Abatement coefficient g in RCC-MRx RB3650 (for high-temperature type-P nuclear piping analysis)

Irénée Cornaton[1], Chau-Thuy Pham[1], and 'To be defined'[2]

Figure 1: A typical piping structure modelled under PEPS 8.0 (to modify this model – it's from client)

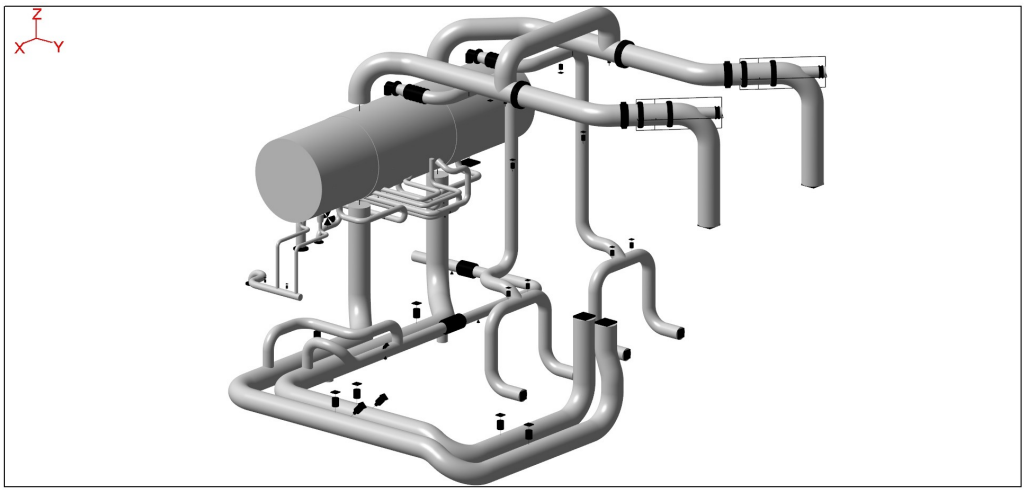
For the above figure: add some equipments, remove all small piping portions ; add all components mentionned in the first paragraph in this structure

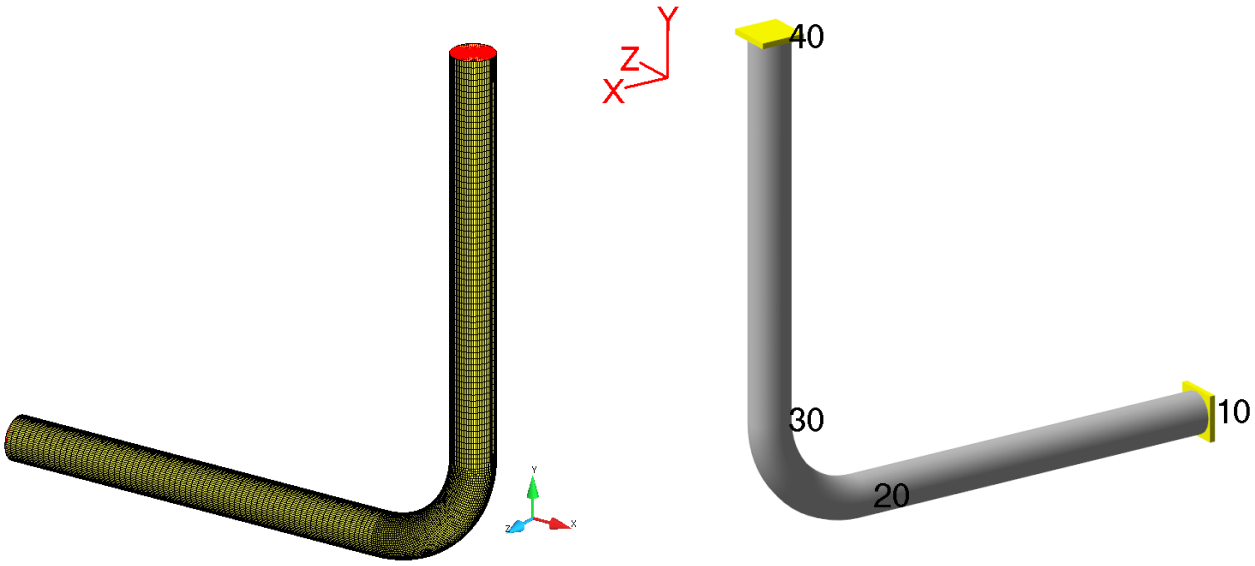
Present the impact of pressure on the ovalization here + introduce the pressure ovalization correction

Note: it might be impossible to consider pressure in this work. Because Marc will have to explicitly consider pressure load, but here we only want the pressure effects on the elbows' flexibility (deformation) and consider only thermal exp −> to discuss more

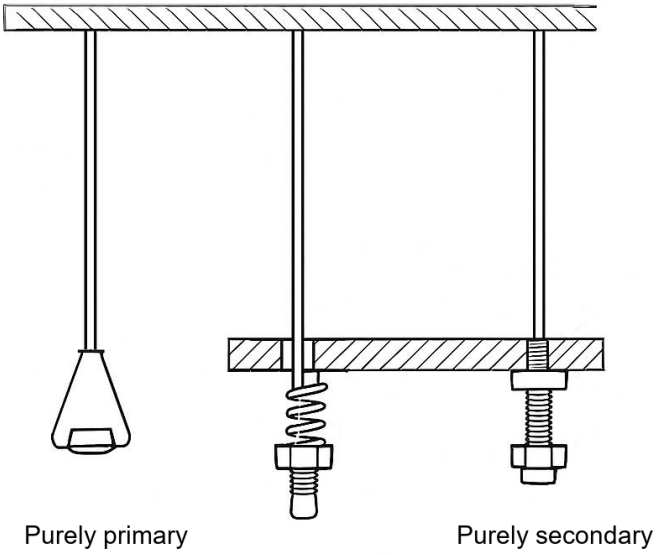
Figure 6: Source-presentation mechanical analogy contrasting a purely primary load (left: a weight hanging freely, force-controlled) with a purely secondary load (right: a bolt rigidly fixed against a support, displacement-controlled); the intermediate spring-mounted bolt illustrates the elastic-follow-up case discussed next. –> we might redo completely this image, or use a figure from a referenced document

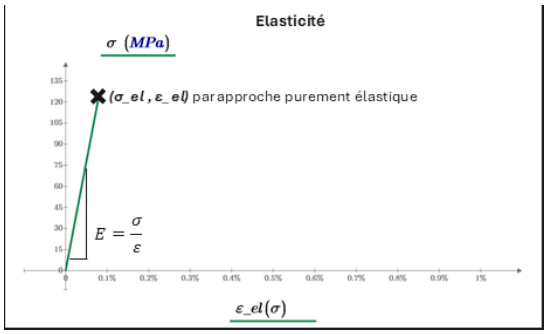
Figure 7: Slide-level graphical construction (slide 16) of the common elastic reference point $(\sigma_{\mathrm{el}}, \varepsilon_{\mathrm{el}}) = (126\,\mathrm{MPa}, 0.081\,\%)$ shared by Bars 1 and 2, obtained independently from F_1/S (Bar 1) and $(u_2/L)E$ (Bar 2) before the elasto-plastic calculations of Figure **??** are run. –> to remove

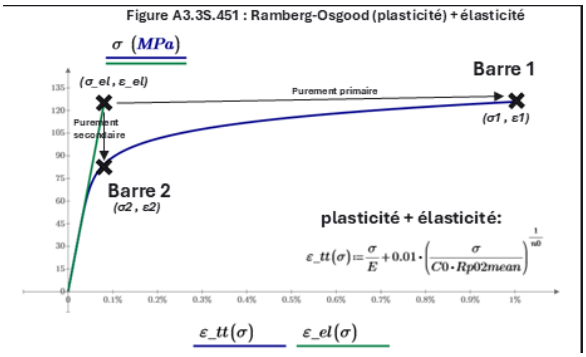
Figure 8: Ramberg–Osgood curve (RCC-MRx Figure A3.3S.451) with Bar 1's purely primary point $(\sigma_1, \varepsilon_1)$ and Bar 2's purely secondary point $(\sigma_2, \varepsilon_2)$ located relative to the common elastic point $(\sigma_{\mathrm{el}}, \varepsilon_{\mathrm{el}})$, reproduced from the presentation. –> to remove

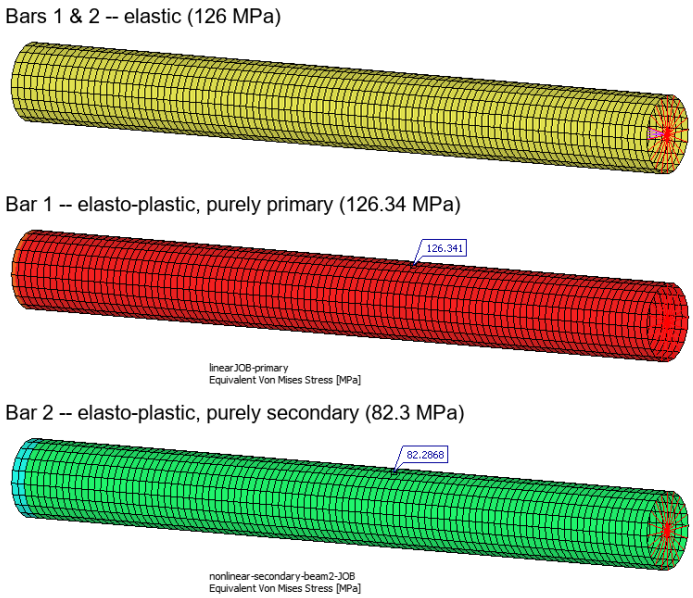
Figure 9: MSC Marc equivalent von Mises stress contours for the DN200 toy example. Top: common elastic state shared by Bars 1 and 2 (126 MPa). Middle: Bar 1's elasto-plastic, purely primary response (*linearJOB-primary*), remaining close to the elastic stress level. Bottom: Bar 2's elasto-plastic, purely secondary response (*nonlinear-secondary-beam2-JOB*), relaxing to a markedly lower stress – the self-limiting behaviour characteristic of displacement-controlled loading. –> higher quality

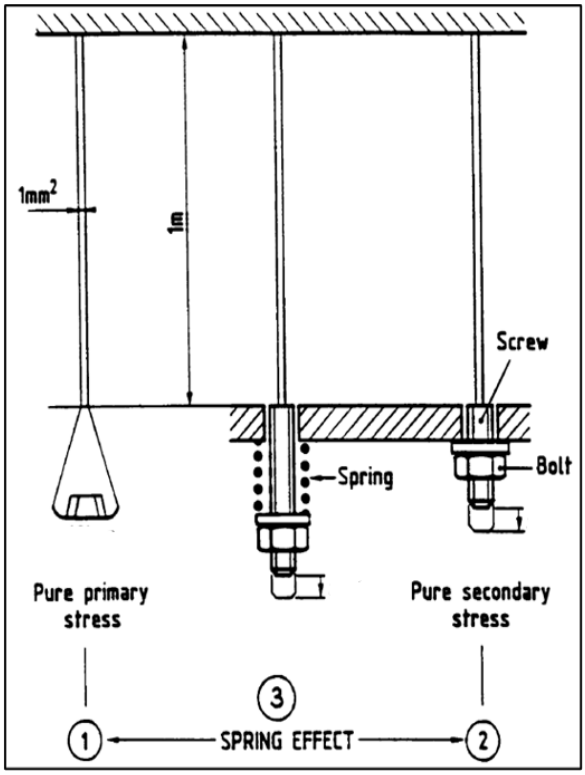
Figure 10: Roche's original spring-bar analogy: Bar 1 (left) carries a pure primary stress (dead-weight-like load); Bar 2 (right) carries a pure secondary stress through a rigid bolted connection; Bar 3 (centre), connected through a soft spring, reproduces an intermediate "spring effect" behaviour between Bars 1 and 2. –> doubly occured figure –> to remove

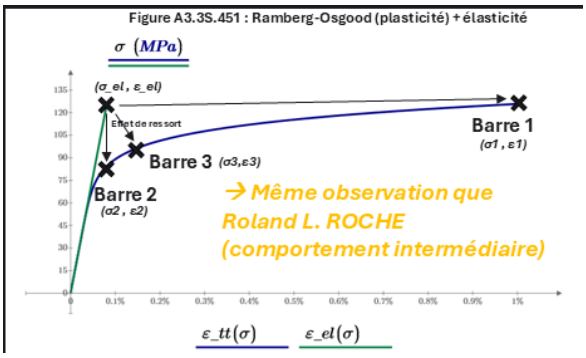
Figure 11: Ramberg–Osgood curve with Bar 3's point $(\sigma_3, \varepsilon_3)$ ("spring effect") added to Bars 1 and 2, showing at a glance the intermediate character of the spring-effect response, before the parametric sweep of Figure **??** is introduced. –> important: redo the figure. Maybe reuse figure 2 and modify it –> lecturers will not be disturbed by too many similar figures

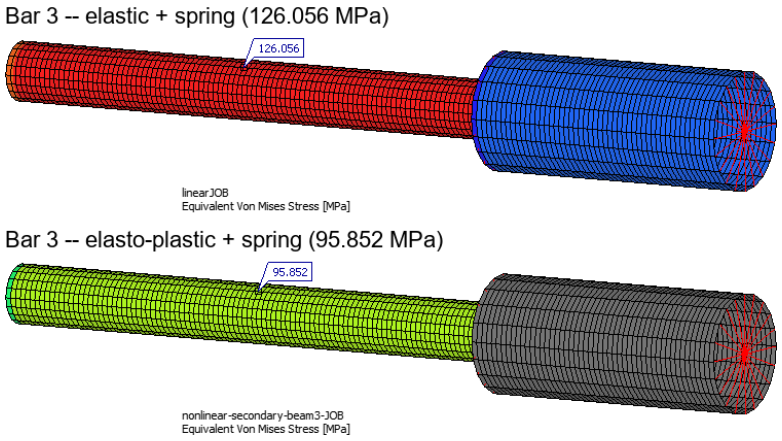
Figure 13: MSC Marc equivalent von Mises stress contours for a second, independent spring-stiffness run on Bar 3: elastic reference state (top, 126.056 MPa) and elasto-plastic response (bottom, 95.852 MPa), both showing the flexible bar segment together with the stiffer series-spring segment.–> higher quality

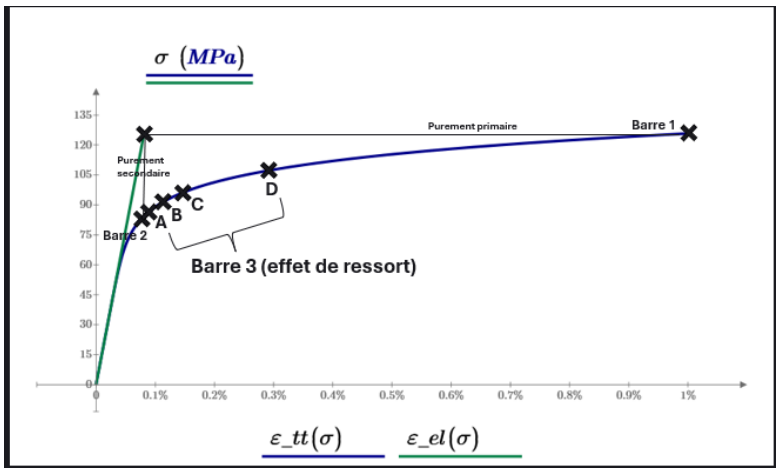
Figure 14: Parametric three-bar sweep extracted from the presentation: reducing the added spring stiffness from $k_2 = 2k$ to $k_2 = k/16$ drives Bar 3 continuously away from the purely secondary limit (Bar 2) and towards the primary-like limit (Bar 1). The slide reports the corresponding sequence of follow-up factors ($r_M = 0.996$, 3.989, 7.981, 31.931), stress estimates ($\sigma_{3,\mathrm{est}} = 89.912\,\mathrm{MPa}$, $97.183\,\mathrm{MPa}$, $101.8\,\mathrm{MPa}$ and $111.4\,\mathrm{MPa}$) and end displacements ($u_3 = 2.435\,\mathrm{mm}$, $4.869\,\mathrm{mm}$, $8.115\,\mathrm{mm}$ and $27.591\,\mathrm{mm}$). –> higher quality + Maybe reuse figure 2 and modify it –> lecturers will not be disturbed by too many similar figures

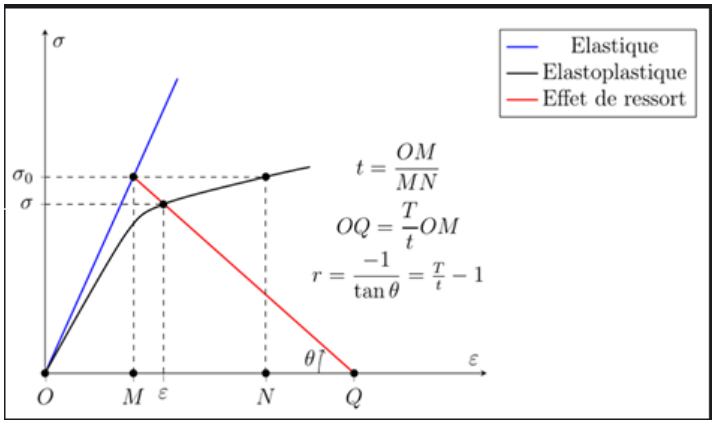
Figure 16: Graphical construction of r_M, reproduced directly from the presentation: $\sigma_0 = \sigma_{\text{el}}$ is the elastic reference stress at point M, σ the actual elasto-plastic stress reached at the same strain ε; the local resilience is $t = OM/MN$, the global resilience T is such that $OQ = (T/t)\,OM$, and the spring-effect line of slope $-1/r_M = \tan\theta$ passes through M and Q.–> to be replaced by a latex code + make it similar to Figure 2

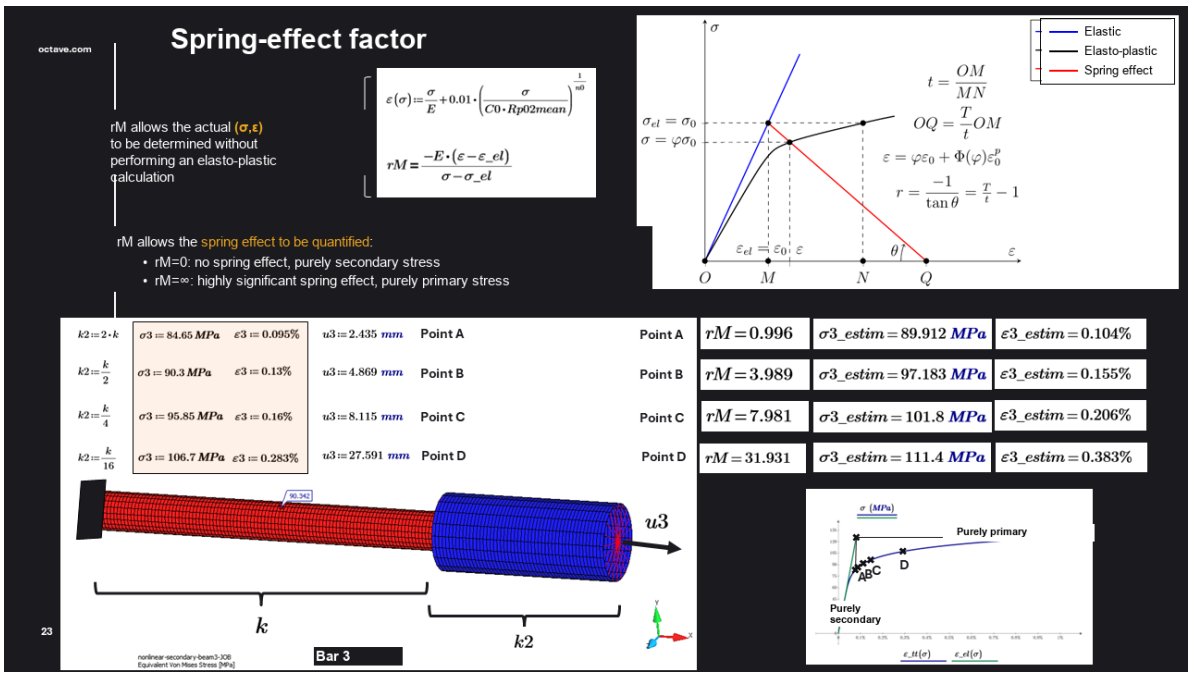
Figure 17: Parametric three-bar sweep extracted from the presentation: reducing the added spring stiffness from $k_2 = 2k$ to $k_2 = k/16$ drives Bar 3 continuously away from the purely secondary limit (Bar 2) and towards the primary-like limit (Bar 1). The slide reports the corresponding sequence of follow-up factors ($r_M = 0.996$, 3.989, 7.981, 31.931), stress estimates ($\sigma_{3,\mathrm{est}} = 89.912\,\mathrm{MPa}$, $97.183\,\mathrm{MPa}$, $101.8\,\mathrm{MPa}$ and $111.4\,\mathrm{MPa}$) and end displacements ($u_3 = 2.435\,\mathrm{mm}$, $4.869\,\mathrm{mm}$, $8.115\,\mathrm{mm}$ and $27.591\,\mathrm{mm}$).–> to redesign. Don't let the rM curve occur too many times

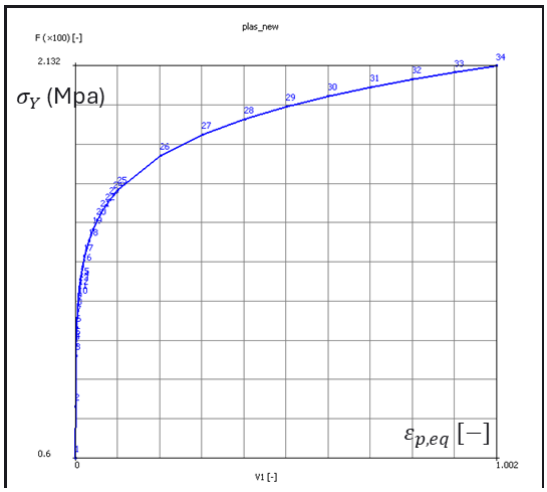
Figure 19: MSC Marc tabulated isotropic hardening curve (*plas_new* table), σ_Y versus equivalent plastic strain $\varepsilon_{p,\mathrm{eq}}$, digitised at 34 points from the zero-offset Ramberg–Osgood law of Eq. (**??**) and used directly as the FE material input. –> higher quality figure to replace

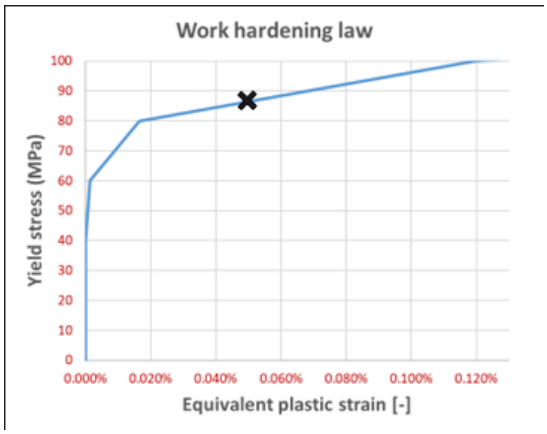
Figure 20: Zoom of the work-hardening law over the small-strain range relevant to the benchmark, with the retained critical-section point ($\sigma_{\mathrm{VM}} = 86.5\,\mathrm{MPa}$, $\varepsilon_{p,\mathrm{eq}} = 0.05\,\%$) marked, confirming its consistency with the imposed FE hardening curve. –> figure to remove

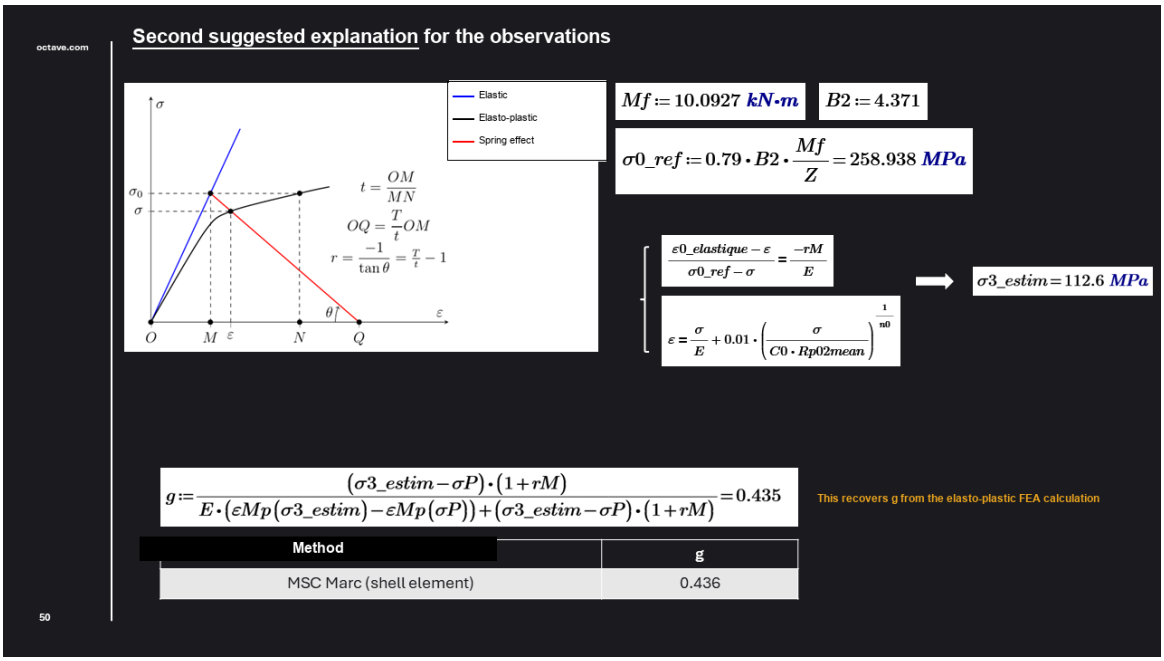
Figure 24: Second FE-side consistency check reproduced from the presentation: starting from the shell-model reaction moment $M_f = 10.0927\,\text{kN m}$ and the piping-code coefficient $B_2 = 4.371$, the equivalent elastic reference stress is reconstructed as $\sigma_{0,\text{ref}} = 0.79\,B_2\,M_f/Z = 258.938\,\text{MPa}$. Solving the coupled elastic-follow-up and Ramberg–Osgood relations shown on the slide then gives $\sigma_{3,\text{est}} = 112.6\,\text{MPa}$ and $g = 0.435$, i.e. the reaction-based FE abatement coefficient $g_{\text{reaction}} = 0.436$ to within rounding. –> to redesign

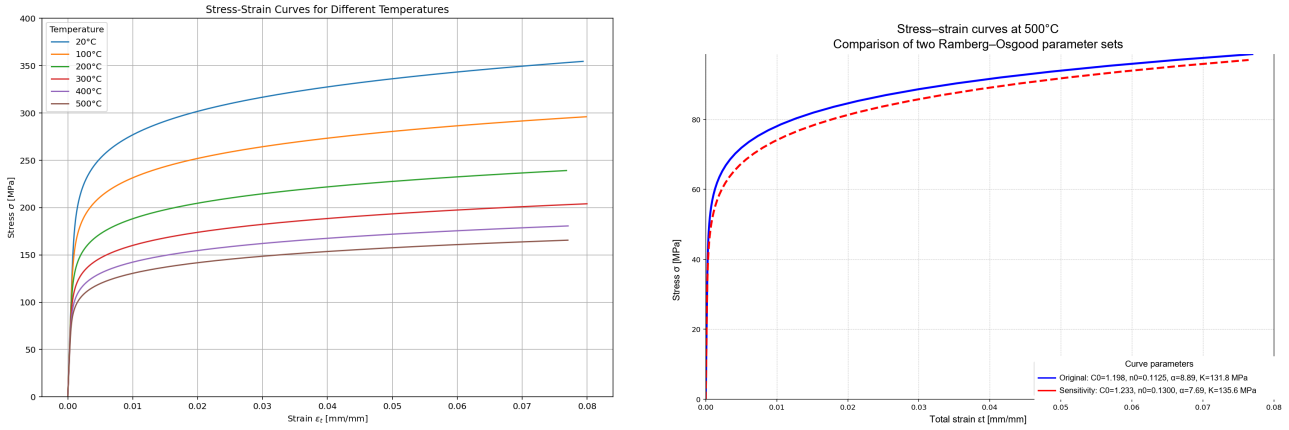
Figure 25: Ramberg–Osgood material data extracted from the presentation. Left: family of 316L(N) stress–strain curves used to justify the temperature-dependent scaling of the law through $R_{p0.2}(T)$. Right: sensitivity check at 500 °C (a different temperature from the 550 °C benchmark), comparing the reference parameter set ($C_0 = 1.198$, $n_0 = 0.1125$, $C_0 R_{p0.2} \approx 131.8$ MPa) with the alternative fit ($C_0 = 1.233$, $n_0 = 0.130$, $C_0 R_{p0.2} \approx 135.6$ MPa) discussed in the text. –>show the importance of n0/C0 on the final results
